DOUBLE H SUBDIVISION, RESUBDIVISION OF LOT 1

APPLICATION NUMBER 4 DATE August 5, 2010

REQUEST Subdivision

DETAIL SITE PLAN

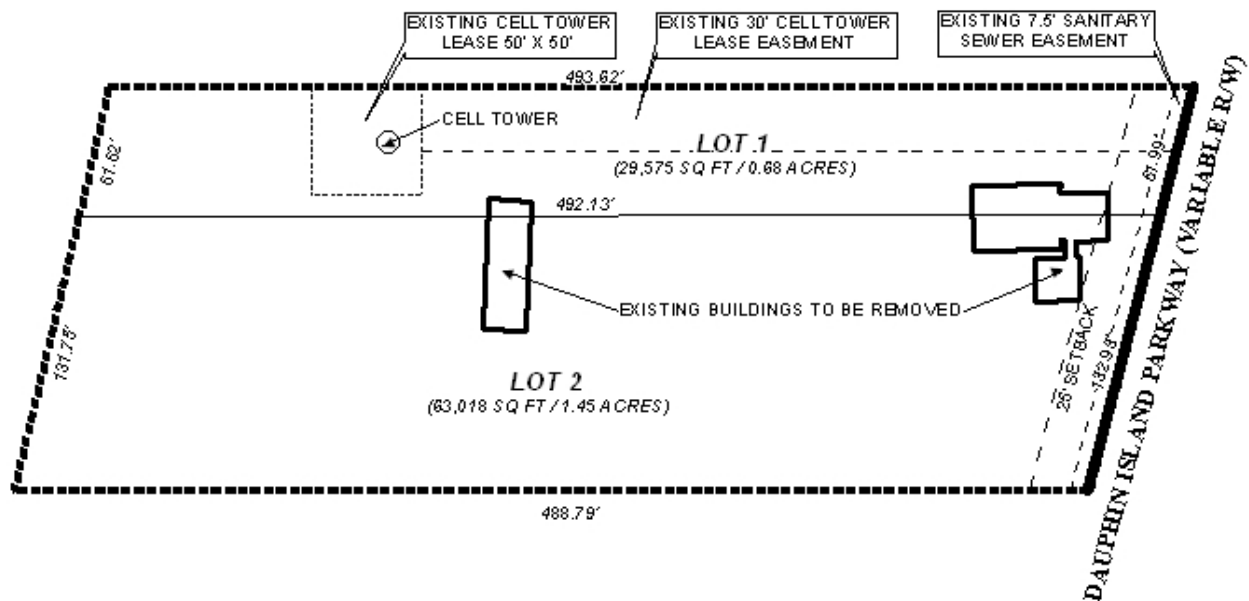
While Dauphin Island Parkway is a major street, access management is still a concern; therefore, a note should be placed on the Final Plat stating that each lot is limited to one curb-cut along Dauphin Island Parkway with the size, location, and design of any additional curb-cuts to be approved by Traffic Engineering and ALDOT and conform to AASHTO standards.

As proposed, Lots 1 and 2 exceed the maximum width to depth ratio; therefore, a waiver of Section V.D.3. of the Subdivision Regulations would be required.

The 25-foot minimum building setback line is depicted on the preliminary plat and should be retained on the Final Plat adjusted for any dedication, if approved.

The plat depicts two existing buildings that cross the proposed interior lot line: a demolition permit should be required for each structure prior to the signing of the Final Plat.

- 1) obtaining of demolition permits for the existing structures crossing the interior lot line prior to signing the Final Plat;
- 2) placement of a note on the Final Plat stating that each lot is limited to one curb-cut along Dauphin Island Parkway with the size, location, and design of any additional curb-cuts to be approved by Traffic Engineering and ALDOT and conform to AASHTO standards;

- 3) retention of the 25-foot minimum building setback line along Dauphin Island Parkway;
- 4) retention of the labeling of the size of the lot, in square feet, or provision of a table on the plat with the same information;
